Presentation #3 – Public Space and Transportation

RiverHouse

Rezoning (REZN22-00007)

Phased Development Site Plan (SPLN23-00001)

Green Ribbon (Primary Route): Land Bay S Segment

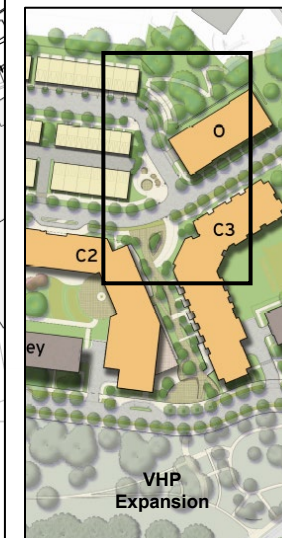
Path compressed by building placement

Missing crosswalk and ADA ramps

Multiple street crossings vs. minimal crossings

Path quality, visibility and continuity diminished by building/street placement

Path width only 8 ft. (vs. 12 ft. recommended)

No separated bike path throughout

Garage entrance conflict point

Green Ribbon (Primary Route): Land Bay C Segment Issue Areas

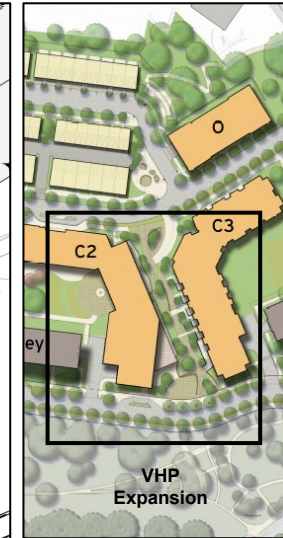
Narrow corridor limits opportunity for wider paths and planting areas; accommodation of grade change

Separated bike path not provided

12-ft. width path for both bikes and peds. (vs. 18 ft. for combined use)
